MODELS:
REASON:

1963-69 Serpentine
To provide an Anti-Theft Device to prevent the Access Door
from being Pried Open.

B/M 143,011,800.04 Anti Theft Access Door Lock Kit

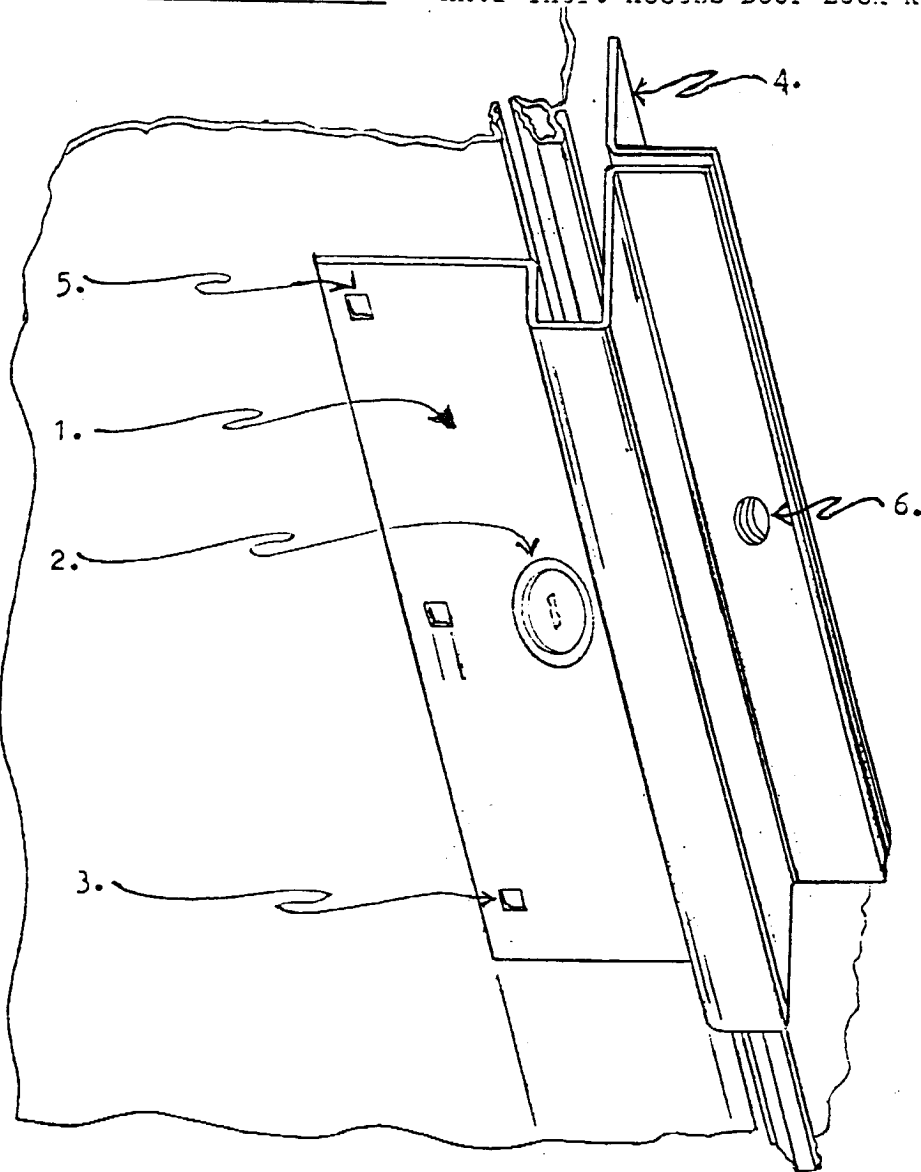
1. C1220.06 Anti-Theft Plate - Access Door
2. Locate 1 5/16" Dia. hole over lock as shown on figure
3. Drill 9/32" Dia. holes six (6) places - - - 3 holes in access door - - - 3 holes in leading edge of the main door after
4. Aligning C123.06 Anti-Theft Plate - - - Main Door Frame with C122.06
5. Secure with carriage bolts and nuts.
6. Padlock Holes
